ODCM-03.01 Rev 1, Gaseous Effluents

Summary of Changes

MONTICELLO NUCLEAR GENERATING PLANT		ODCM-03.01
TITLE:	GASEOUS EFFLUENTS	Revision 1
		Page 1 of 23

ODCM-12.05 Rev 1, ODCM-05.01 Figures

ODCM-05.01 FIGURES

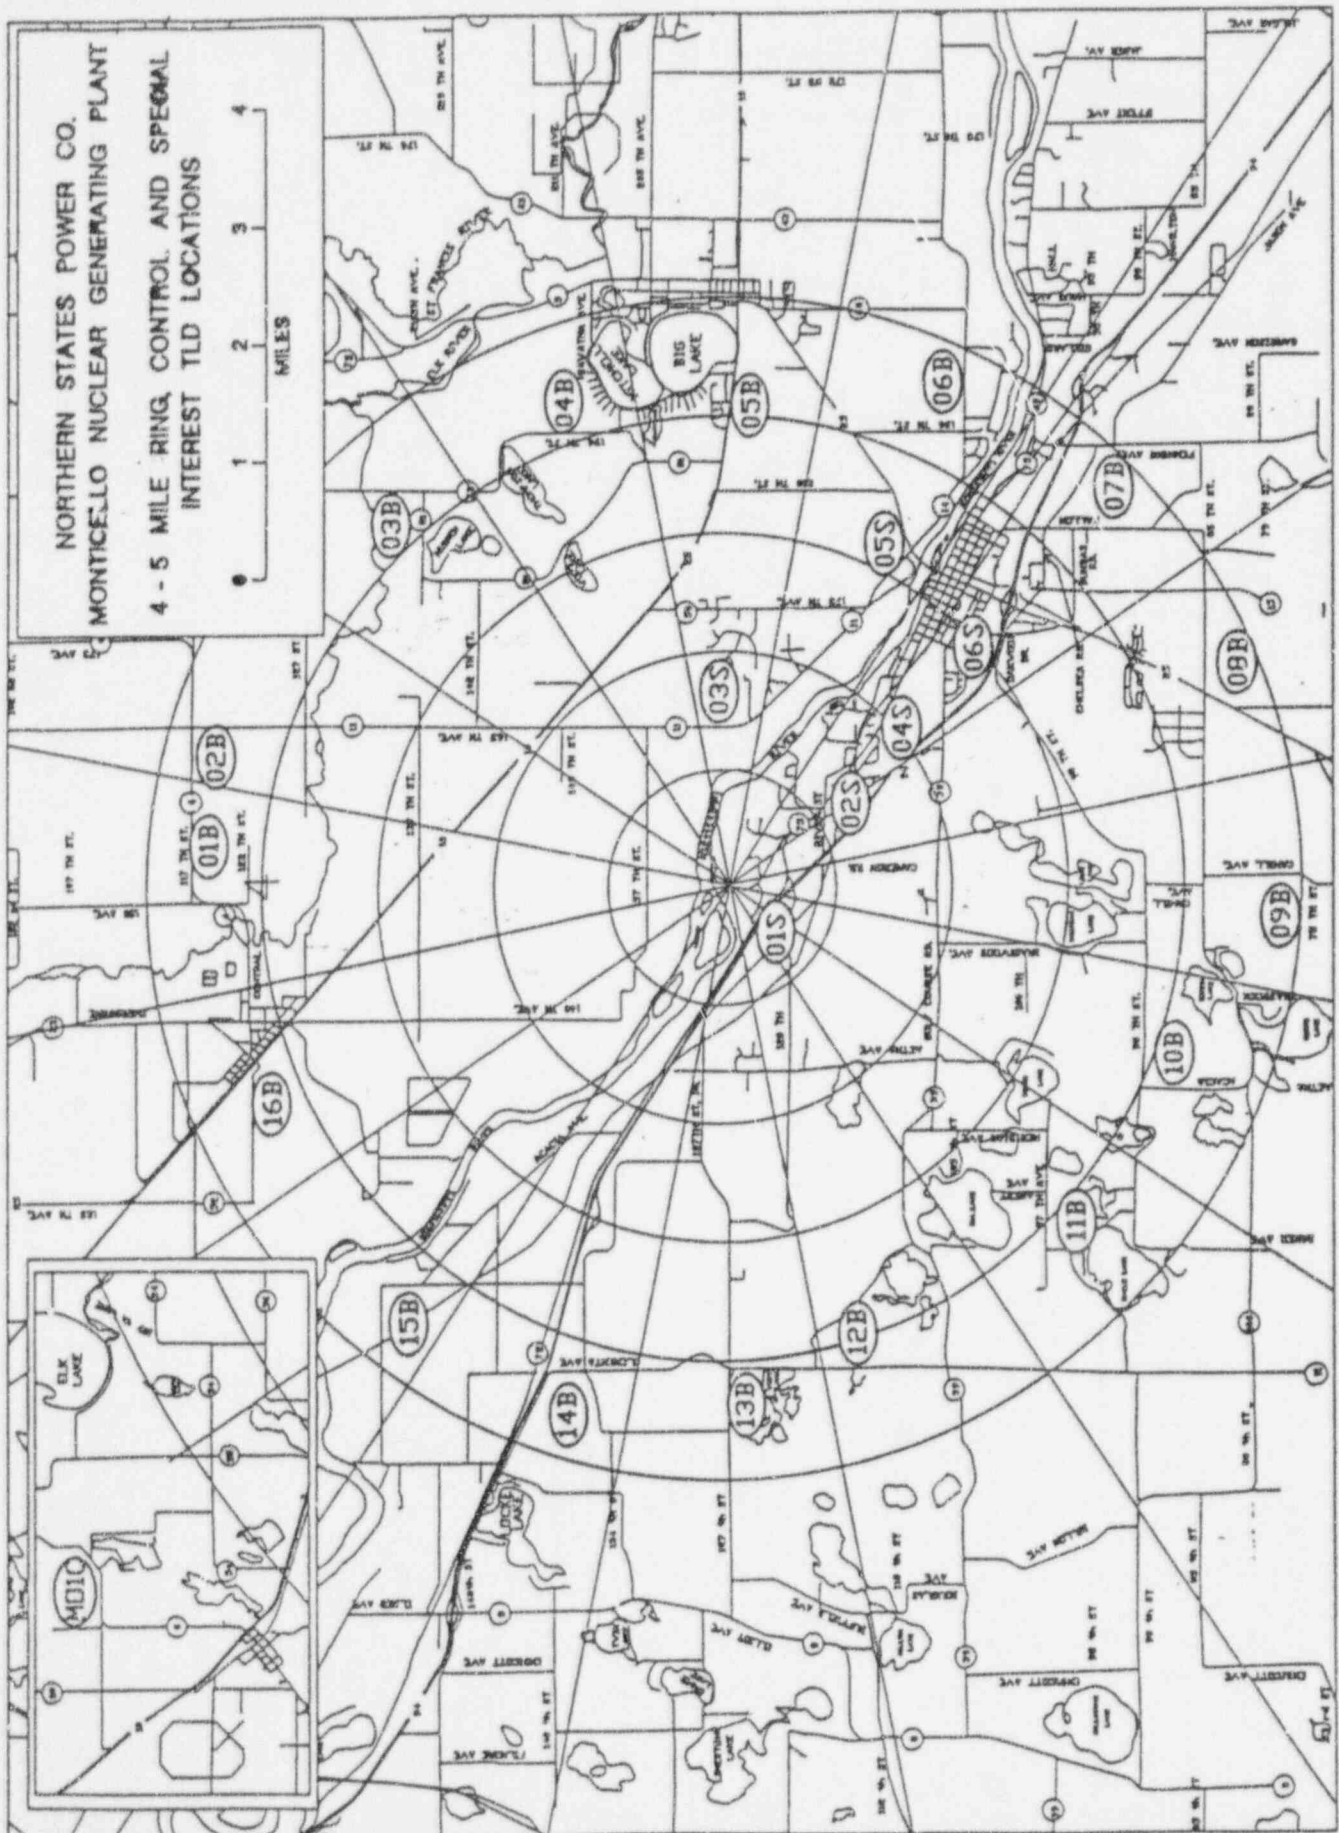
Section/Page	Changes/Reason for change
ODCM-12.05 2 of 4	Updated the map of REMP sampling locations This change was made because the locations had changed.
ODCM-12.05 3 of 4	Updated the map of 4-5 mile ring control and special interest TLD locations. This change was made because a TLD (05S) location had changed.
